DOCKETED	
Docket Number:	24-OPT-02
Project Title:	Compass Energy Storage Project
TN #:	257871
Document Title:	Cathleen Pryor Comments - Better map of the danger to railway lines
Description:	N/A
Filer:	System
Organization:	Cathleen Pryor
Submitter Role:	Public
Submission Date:	7/20/2024 8:58:49 AM
Docketed Date:	7/22/2024

Better map of the danger to railway lines

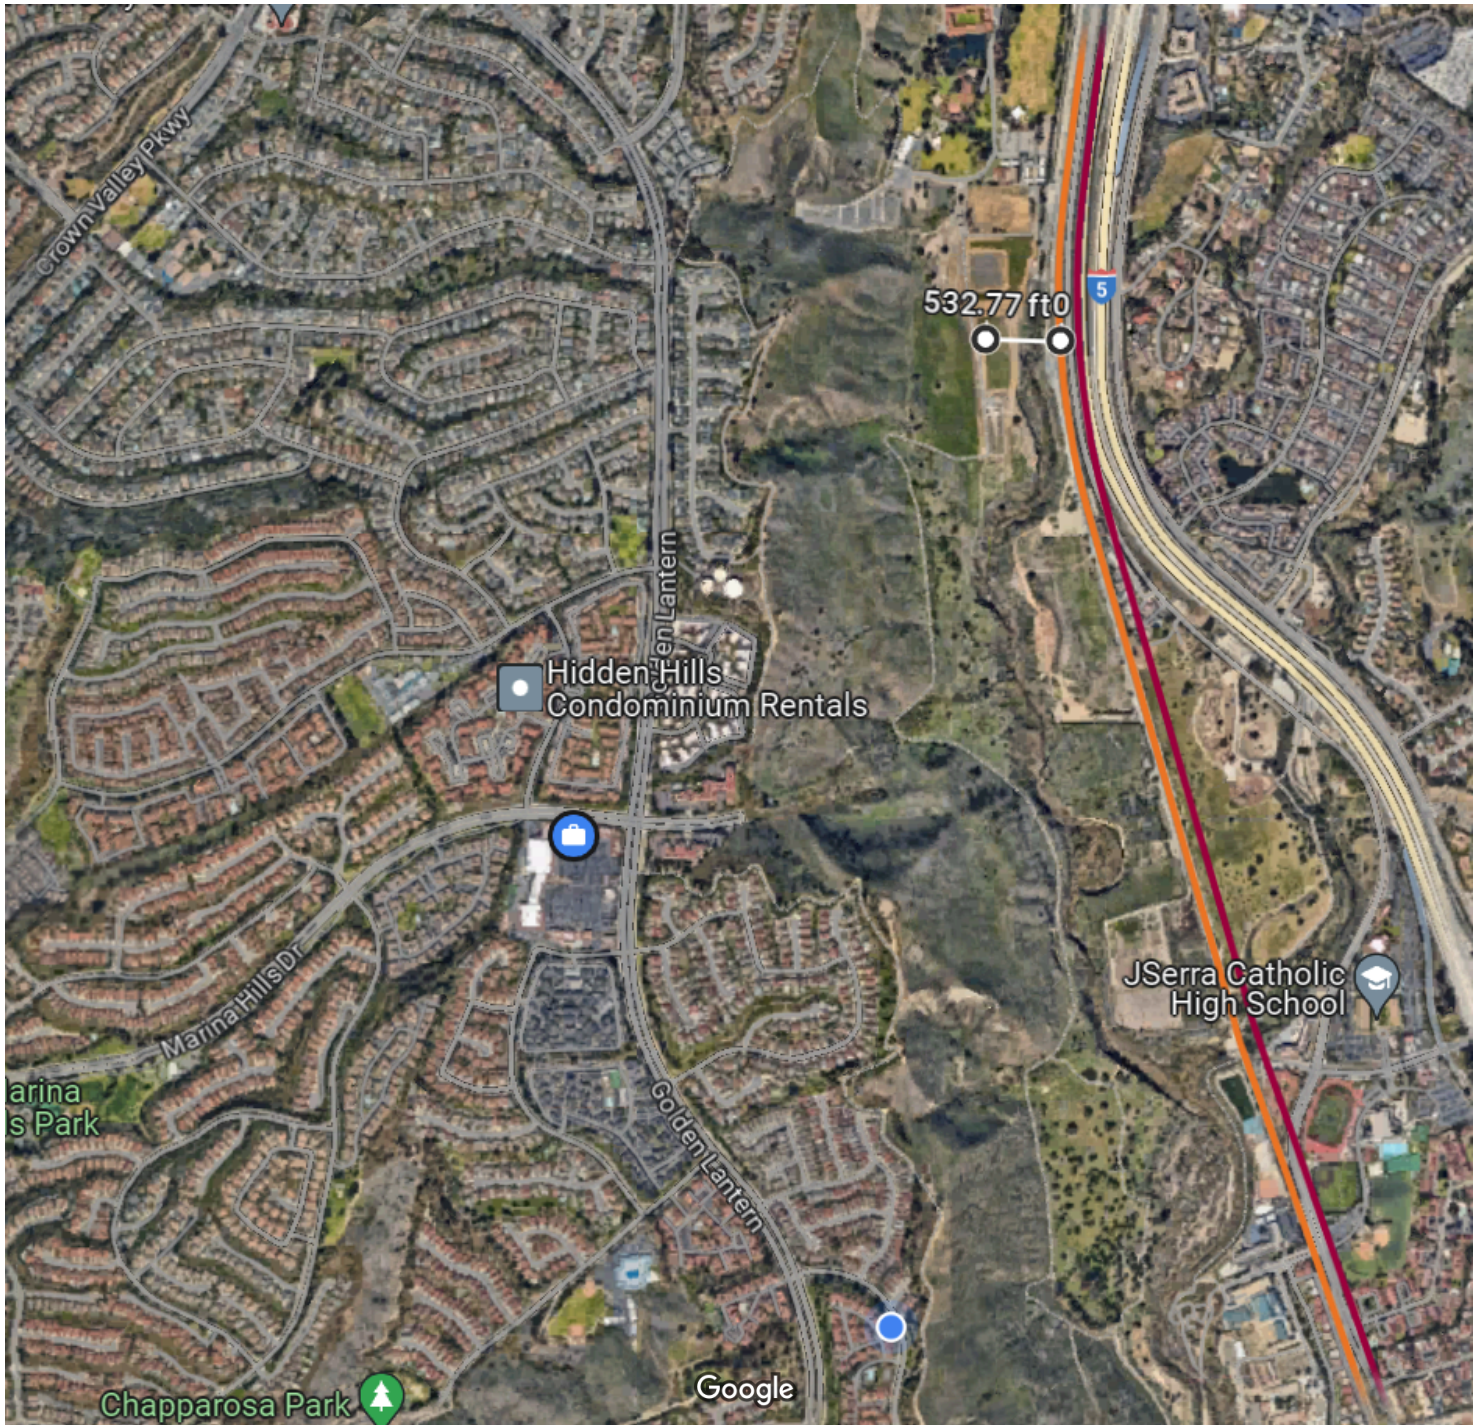
This map shows how close the facility would be to the Metrolink Orange County line and the Inland Empire Metrolink line. When a fire breaks out, these trains would too close to continue to run. Lithium fires take days or weeks to burn thoroughly. We can anticipate fire would spread from container to container by embers flying into the a/c units on each container. This recipe for Lithium batteries is not explosive like Lithium Cobalt but it is flammable and the containers have air ducts sucking in outside air and would be dusty with particles from the hillsides. Because the hills are hundreds of feet higher and so close, dust, animal debris, pollen, etc. will rain down on them daily. I do not know how they could keep the outside or inside clean. All of that is flammable and next to massive amounts of electricity flowing in each direction. It would be a disaster scenario.
